TO: Design Advisory Board
FROM: Ken Lerner
DATE: August 12, 2014
RE: 15-0054CA/CU, 711 Riverside Avenue

Zone: RM Ward: 2
Date application accepted: July 11, 2014
Applicant/ Owner: Burlington Housing Authority
Request: Conditional use to establish and construct a six bedroom Community House with attached one bedroom apartment.

PROPOSED SITE PLAN

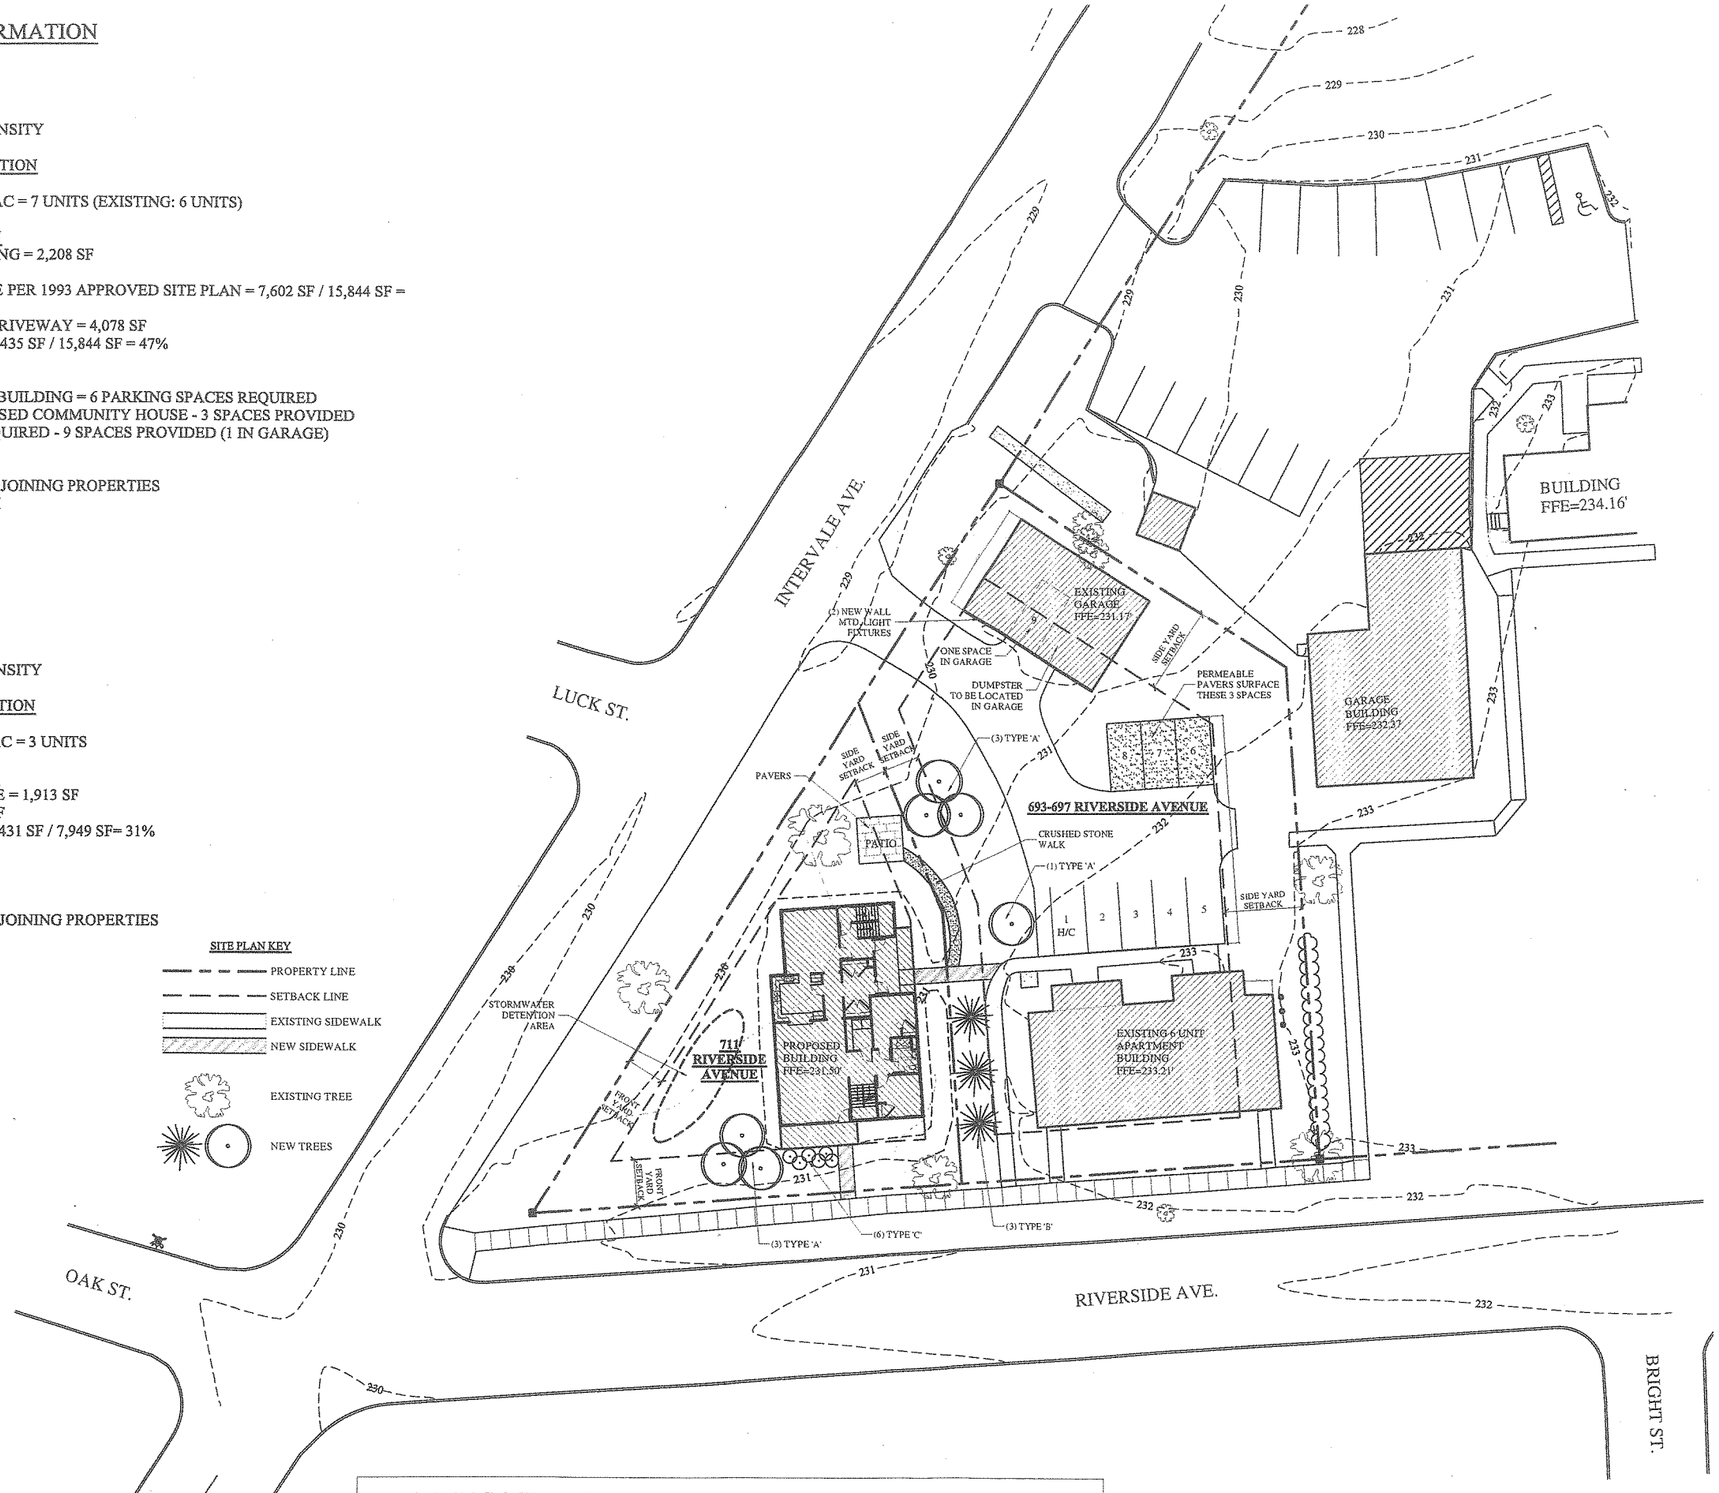
Bicycle parking is not required but should nonetheless be provided to some extent. There are storage rooms in basement that could be used for long-term bike storage, but requires negotiating stairs. No exterior short-term bike racks are shown and should be provided.

(m) Landscaping and fences
Landscaping details have been provided. A stormwater detention area to capture and infiltrate roof runoff into the soil is provided at the west corner of the property. Impervious areas as proposed will total 31% of the property; 40% is the maximum permissible. A patio with pavers is proposed on the north side of the building for use by the occupants.

(p) Integrate infrastructure into the design
Any new utility lines must be buried. Utility meters must be appropriately located on the side of the building and screened

(h) Integrate infrastructure into the building design
As noted above, utility meter locations need to identified and should be located on the side of the building. No exterior mechanical equipment is included in the project plans. Trash handling also needs to be addressed.

1. Trash/recyclable handling.
2. The parking spaces to be used for the community house must be dedicated by a permanent legal instrument to assure that they will remain committed to the subject property in perpetuity
3. Utility meter location and screening – preferably on the side of the building.
4. Written approval of the Erosion Prevention and Sediment Control (EPSC) Plan will need to be obtained from the City Stormwater Administrator.
5. Bicycle parking should be provided to some extent. There are storage rooms in basement that could be used for long-term bike storage, but requires negotiating stairs. No exterior short-term bike racks are shown and should be provided.
